Riley Purgatory Bluff Creek Watershed District Permit Application Review

Permit No: 2022-051

Project: Shoreline Stabilization – The applicant proposes restoring 32 feet of Lotus Lake shoreline and installing 23 feet of sand blanket along the shoreline.

Reviewer: Scott Sobiech, PE, Barr Engineering

01 SHORELINE PLAN
 Scale: 3/16" = 1'-0"

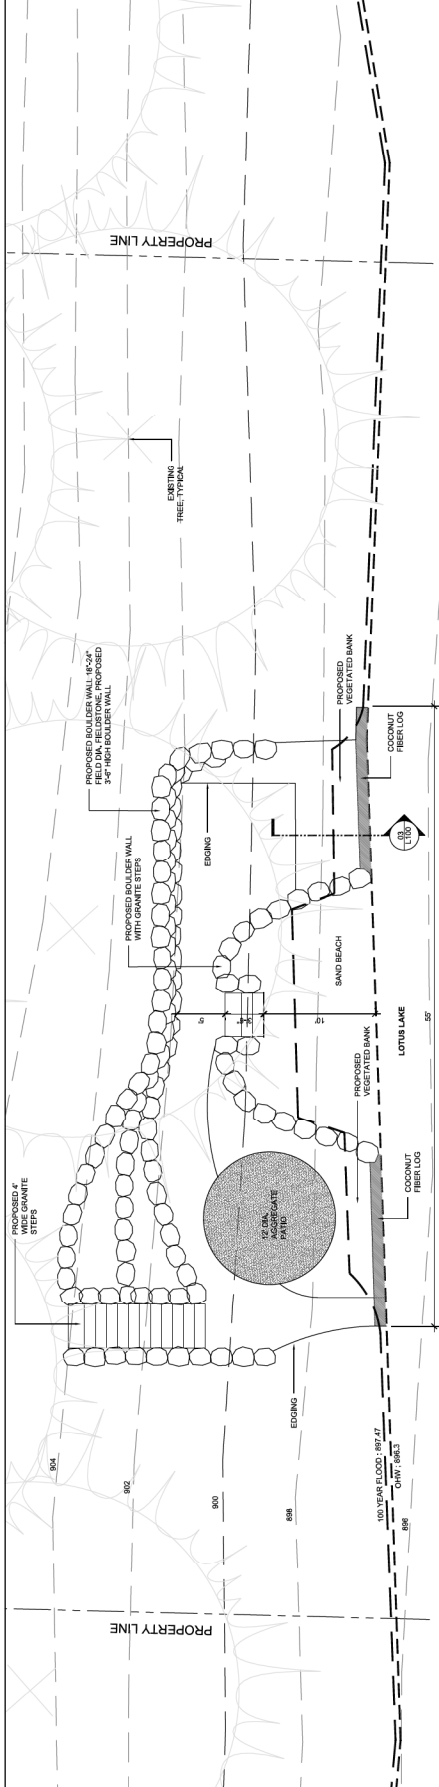
Because the proposed slope shown on the design plan is 3:1 (horizontal to vertical) or flatter waterward of the ordinary high water level, the project conforms to Rule F, Subsection 3.3.a.ii. Design plans also

indicate proposed restoration will follow the configuration of the existing shoreline and only encroach horizontally from the existing shoreline the minimal amount need to install the propose 8-inch coir rolls for restoration. As a result, the proposed project conforms to Rule F, Subsection 3.3.a.iii. The applicant developed the design based on site erosion intensity using RPBCWD erosion intensity scoresheet which accounts for fetch, prevailing wind direction and soils at the site, thus conforming to Rule F, Subsection 3.3.a.iv.

Because the sand blanket section detail on sheet L200 combined with plan view on sheet L100 indicate the proposed sand blanket will be six inches thick, 23 feet width, not extend waterward of the OHW more than 10 feet, and calls for the installation of sand, the conforms with Rule F, subsection3.3d.

01 EROSION CONTROL PLAN
Scale: 3/32"=1'-0"

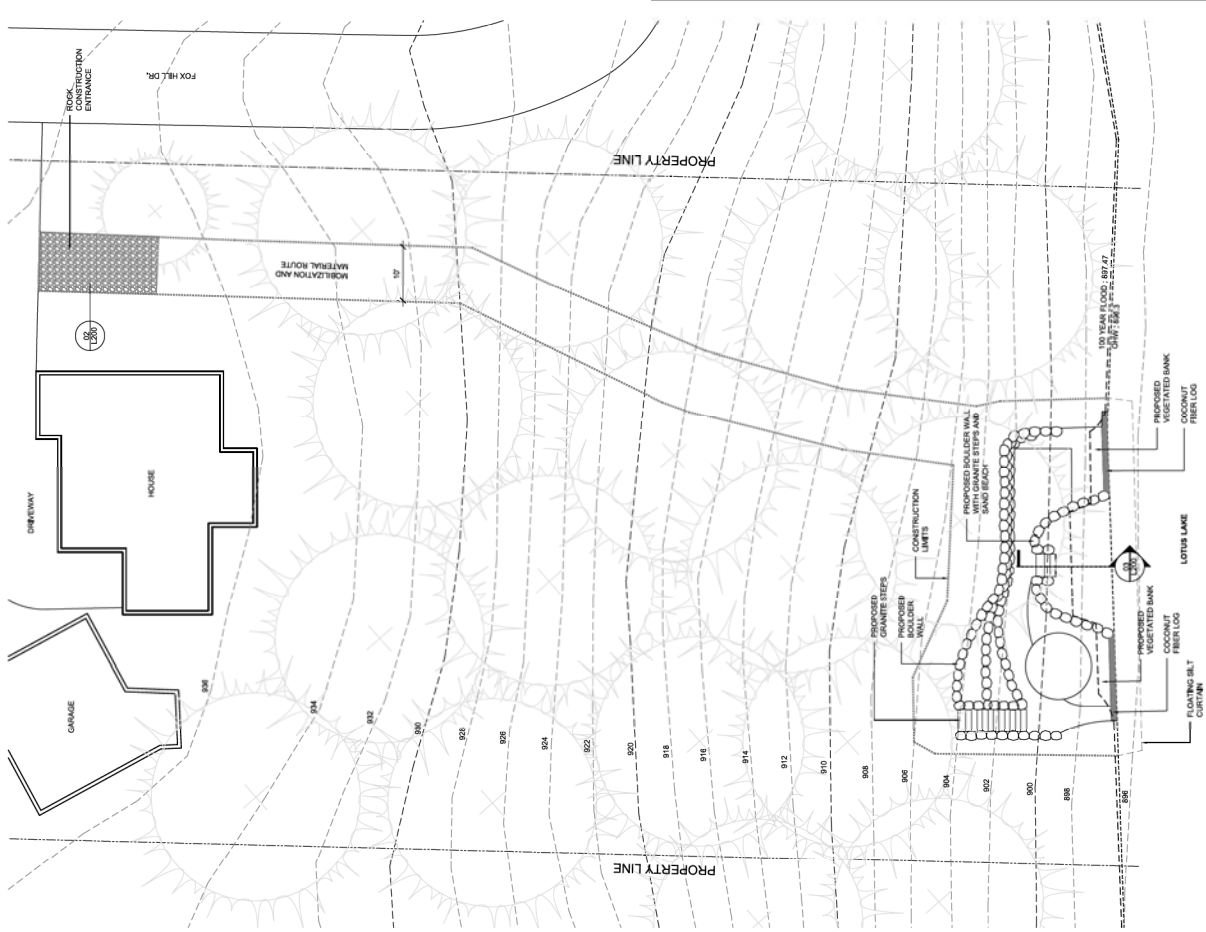
The drawing prepared by Natural Environments Corp includes installation of floating silt curtain, installation of a construction entrance, placement of a minimum of 6 inches of topsoil, and decompaction of areas compacted during construction. To conform to the RPBCWD Rule C requirements the following revisions are needed:

- C1. The Applicant must provide the name and contact information of the general contractor (i.e., specific individual) responsible for erosion and sediment control at the site. RPBCWD must be notified if the responsible party changes during the permit term.

1. The applicant must provide the name and contact information of the individual responsible for erosion prevention and sediment control at the site. RPBCWD must be notified if the responsible party changes during the permit term.
2. The applicant must provide the permit fee deposit to the original amount due before the permit will be issued. As of June 28, 2022 the amount due is \$575.
3. Receipt of a financial assurance in the amount of \$6,696.
